## Report to Planning and Environment Committee

**Subject:** Richmond Hyland Inc. c/o Paul Kitson - Westdell  
Development Corporation  
1725-1737 Richmond Street  
File Number: Z-9741, Ward 9  
Public Participation Meeting

**Date:** July 16, 2024

Figure 12 – Overall Master Plan showing possible development and future phases over the long term

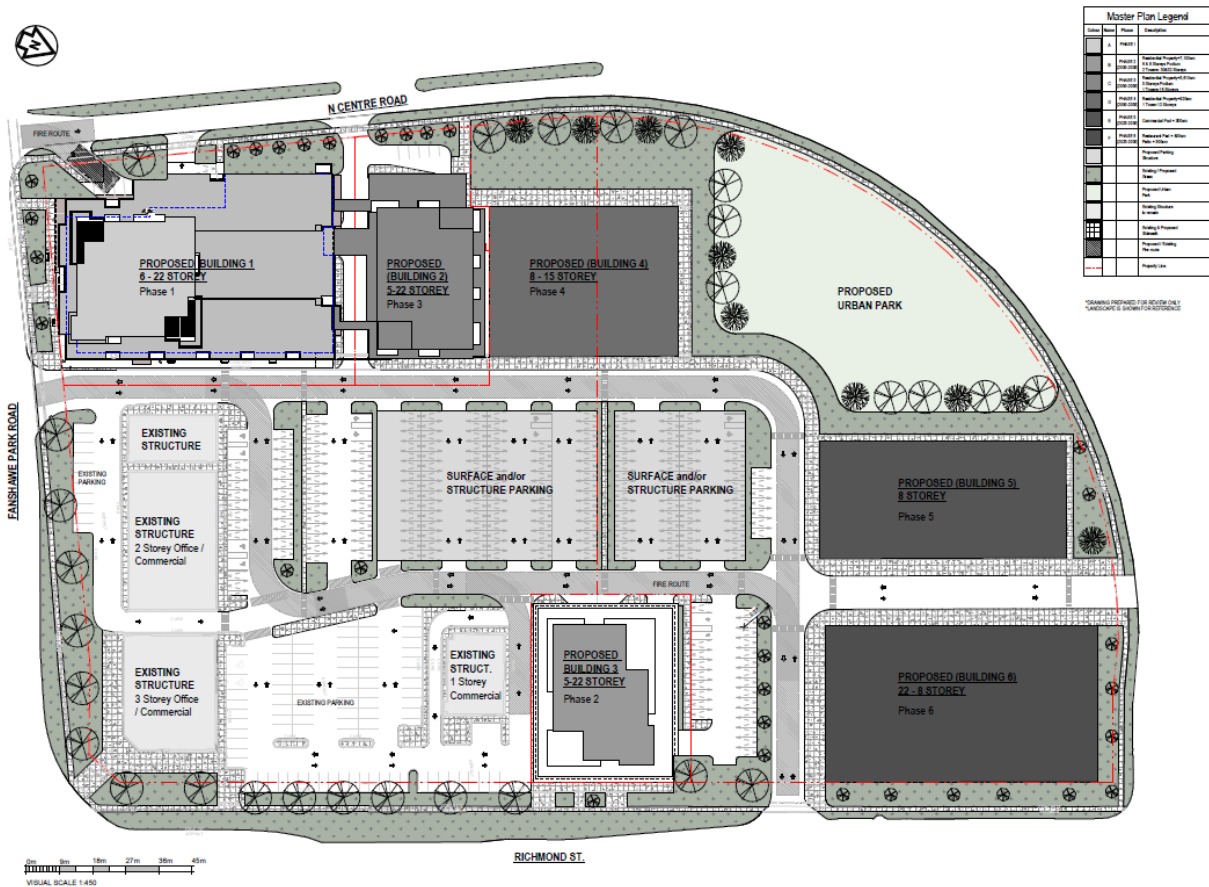
A future parkland block has been proposed for the northwest corner of the site where the current Michaels store is located as shown on Figure 12.

The location for the park proposed in the conceptual master plan is within an existing, tenanted commercial building and is therefore difficult to obtain at this time. During the review of Tower 1, the City accepted cash-in-lieu at the time of Site Plan Approval as an acceptable form of parkland dedication. However, a land dedication in the amount of 0.5 hectares is required through the development of Phases 2 and 3, in accordance with Policy 3.7 of the Masonville Secondary Plan, and is to be secured through the Site Plan Approval process.

Through the Masonville Secondary Plan, the intent is to establish parkland within the plan area to support existing and future residents and complement the parks in the nearby area. As development occurs, the provision of new public parks and privately owned, public spaces (POPS) is identified as a priority. The provision of land for future public parks is prioritized over the collection of cash-in-lieu to establish locations for new open spaces within the Secondary Plan area (3.7 Parks). Due to the number of units proposed through Phases 1, 2, and 3 of development for this site, there is an heightened need for parkland in this area. A new park is required in the northwest quadrant of the master plan area at the classification level of 'urban park' with a minimum size of 0.5ha, in accordance with the Masonville Secondary Plan.

Tower 2 Site Plan Concept

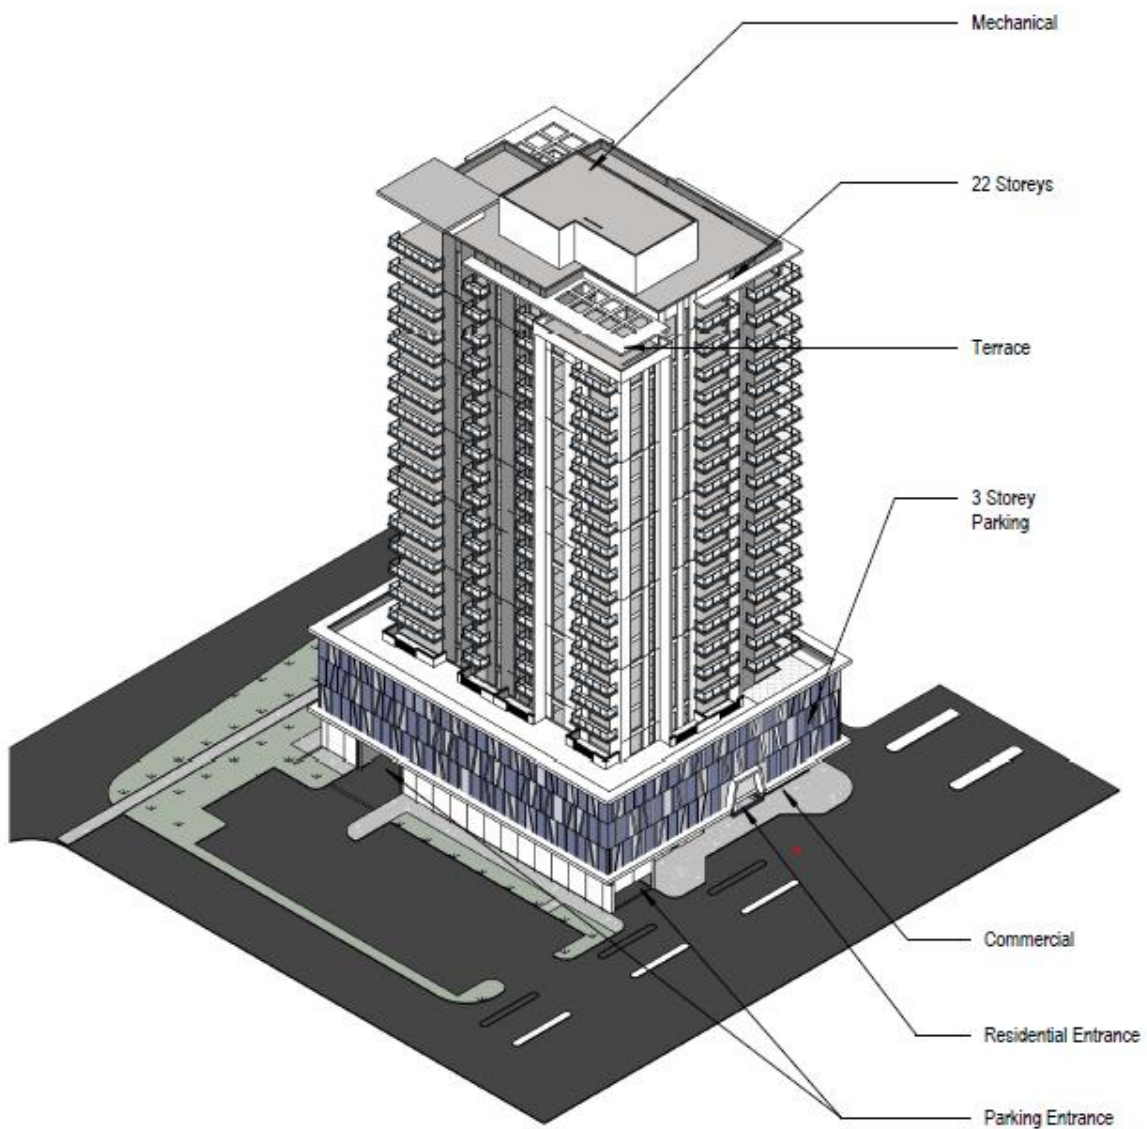
- *TOWER 2:*
- Clarify whether the shown fire route, underground parking access driveway, and surface parking area will be within the same Zone boundary as this Tower. If it will not, then update the parking counts to remove these parking spaces (including the accessible parking spaces). As well, if these lands are intended to be severed off, Staff encourage the applicant to pursue full Site Plan Approval first to ensure that a master Development Agreement is registered on title to avail themselves of Section 4.16.4 of the Zoning By-law and to avoid disconnecting any of these essential site features from this Tower.

- *TOWER 2:*
- At the time of a Site Plan Application (and through the Zoning By-law Amendment process), provide details on the underground and upper parking level plans including parking stall dimensions and a separate plan for each floor of parking.

- Provide a common outdoor amenity space specific to this Tower.
- Visitor parking is required at a rate of 1 per every 10 dwelling units.
- Provide all necessary Fire Route information.

- Provide a north-south pedestrian connection internal to the site from the proposed to the existing commercial buildings to the south.
- *TOWER 3:*
- The proposed waste collection strategy may prove problematic as municipal vehicles can only load from the front of the truck and a dedicated loading space has not been provided for these vehicles.

Tower 3 Site Plan Concept

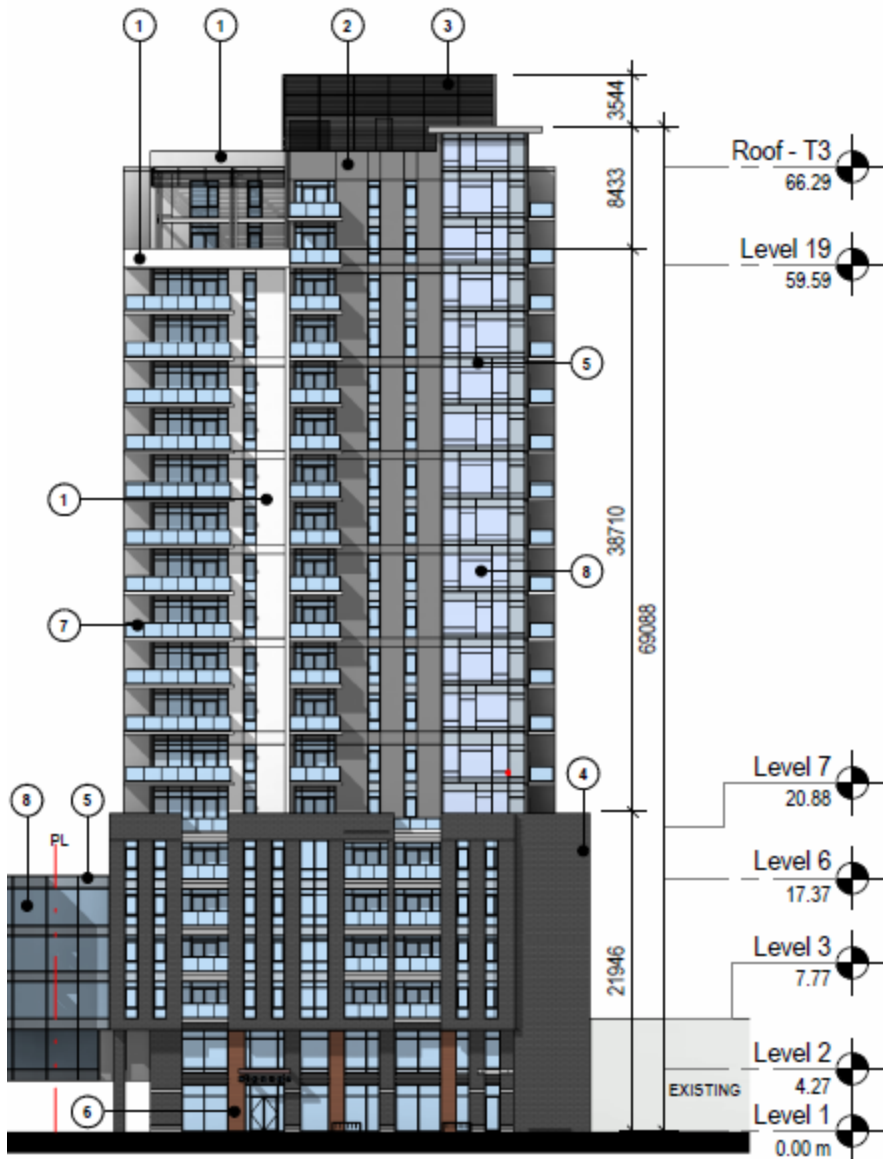
- *TOWER 3:*
- There is no dedicated space for paratransit vehicles or general loading/unloading. Explore options to provide this dedicated space and ensure that it complies with the Site Plan Control By-law standards in terms of size, location, and overhead weather protection.

- Door swings appear to be impeding pedestrian traffic flow along the main east-west sidewalk abutting this Tower.
- It appears that there is no direct connection between the elevators and the dwelling units shown on Floors 2-4. The applicant is to clarify how these residents are expected to access their units in an accessible manner.

- Provide all necessary Fire Route information.
- Identify how snow storage will be handled on site.
